**Re: Defect Information Report – Supplemental Report No. 6
10V-177 School Bus, 10V-178 Non School Bus
FL-577, Hydraulic Brake Switches**

FL577A

Subject: Hydraulic Brake Switches

Models Affected: Specific Freightliner Custom Chassis B2 school bus chassis (Thomas Built Buses Saf-T-Liner C2), S2 shuttle bus chassis, MC motorhome chassis, and Freightliner Business Class M2 vehicles, manufactured between January 19, 2005, and May 5, 2010.

Fig. 1, Brake Switch Location

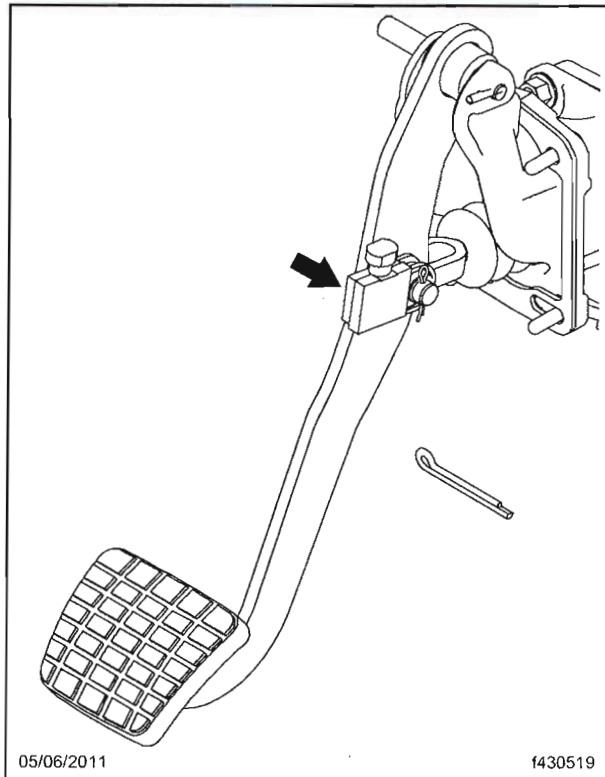
1. Locate the brake switch on the brake pedal. See **Fig. 1** for location of the brake switch.
2. Cut the tie strap on the harness leads going to the brake switch, and unplug the switch.
3. Remove the cotter pin, flatwashers, clevis pin, pigtail harness, and brake switch and discard all of the parts.
4. Install the new clevis pin, flatwashers, brake switch, and hitch pin from the kit. Make certain one flatwasher is between the pushrod and the brake lever as shown in **Fig. 2**.

Fig. 2, Standard Brake Pedal Assembly

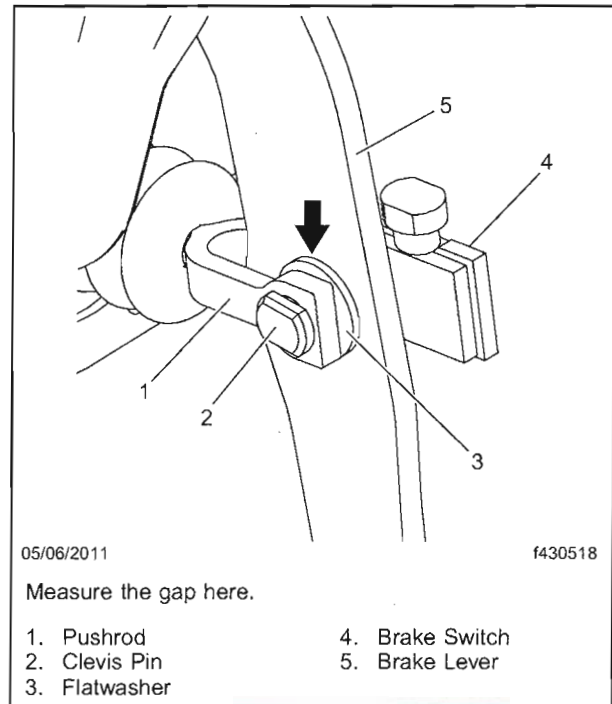
5. Using a feeler gauge, measure the space between the flatwasher and the brake pedal as shown in **Fig. 2**.

If the gap is *less than 1.2 mm*, replace the brake pedal. Go to "Hydraulic Brake Pedal Replacement" in these Work Instructions.

If the gap is *1.2 mm or more*, proceed to the next step.

Fig. 3, New Brake Switch Installation

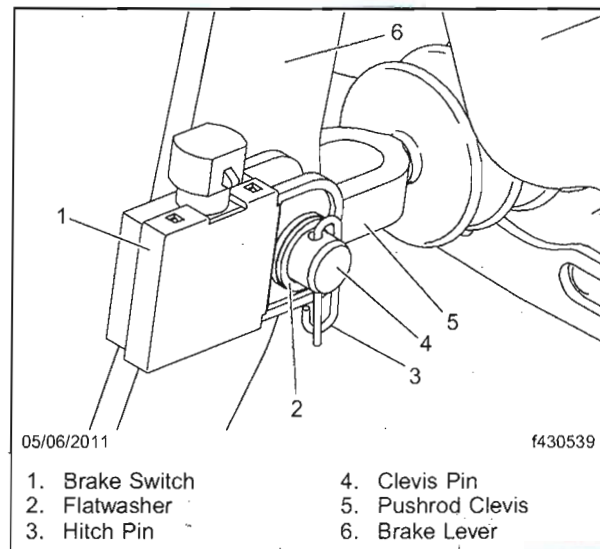
Make certain the other flatwasher is between the brake switch and the hitch pin and that the hitch pin is installed as shown in **Fig. 3**.

Fig. 4, Removing the Brake Pedal

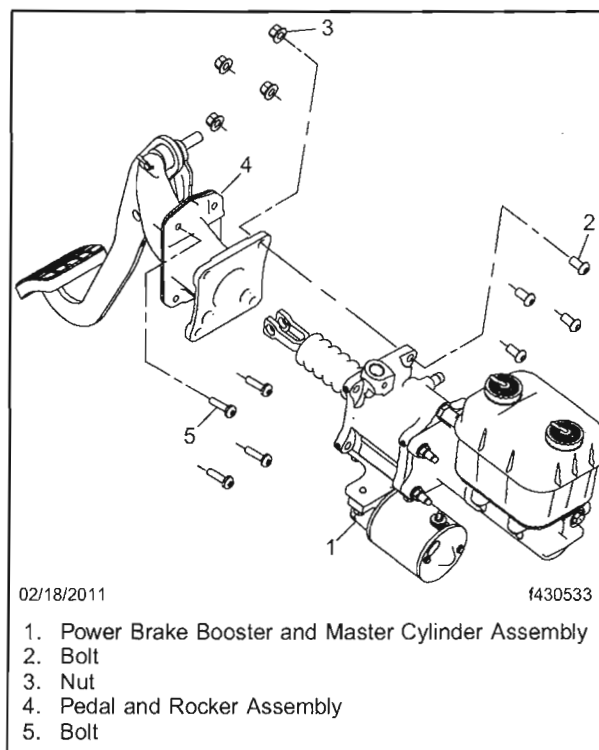
1. Remove the cotter pin from the brake clevis and remove the clevis pin from the brake pedal. See **Fig. 4**.
2. Disconnect the master cylinder from the brake pedal and rocker assembly and support the master cylinder by zip tying it to the engine. Be careful not to bend the hydraulic hard lines.
3. Remove the bolts holding the brake pedal to the frontwall, then pull the brake pedal through the frontwall.
4. Use the existing bolts to install the new brake pedal. Tighten the bolts 10 to 13 lbf-ft (14 to 18 N-m).
5. Connect the master cylinder to the brake pedal.
6. Go to Hydraulic Brake Light Switch Replacement in these Work Instructions.
